**SUNDRY NOTICES AND REPORTS ON WELLS**  
*Do not use this form for proposals to drill or to re-enter an abandoned well. Use form 3160-3 (APD) for such proposals.*

Chevron respectfully request the ability to batch drill the HH SO 10 P3. The wells included in the referenced pad3 include:

Changes to APD for Federal Wells

<b>HH SO 10 P3</b>	<b>7H</b>	<b>30-015-43936</b>
<b>HH SO 10 P3</b>	<b>8H</b>	<b>30-015-43937</b>
<b>HH SO 10 P3</b>	<b>15H</b>	<b>30-015-43930</b>
<b>HH SO 10 P3</b>	<b>16H</b>	<b>30-015-43929</b>
<b>HH SO 10 P3</b>	<b>23H</b>	<b>30-015-43932</b>
<b>HH SO 10 P3</b>	<b>24H</b>	<b>30-015-43926</b>

TA Cap, EBS-F-RH, 9"  
13-5/8" SM  
Part # 399984 - Rental

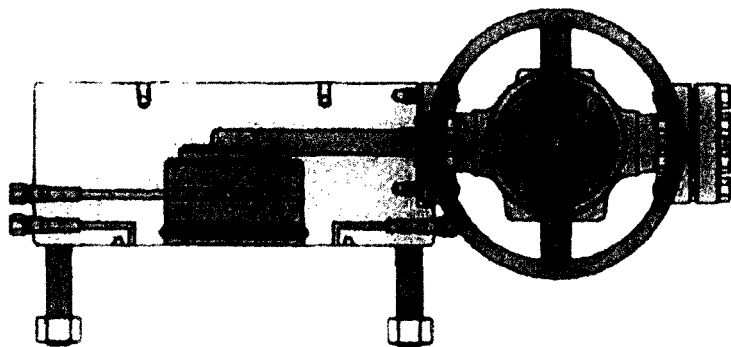
1. Drill 17-1/2" surface hole with fresh water to planned casing set depth with 10' rat hole.
2. Run casing as stated by approved APD, land out wellhead, and cement.
3. Dress out 13-5/8" 5M SH-2 wellhead and install/secure with temporary abandonment cap, and a pressure gauge will be installed. Reference image below *Part U 399984*
4. Skid to next well according to below "Drill Order"  
*Repeat 1 through 3 until all six surface holes are drilled, cased and cemented*
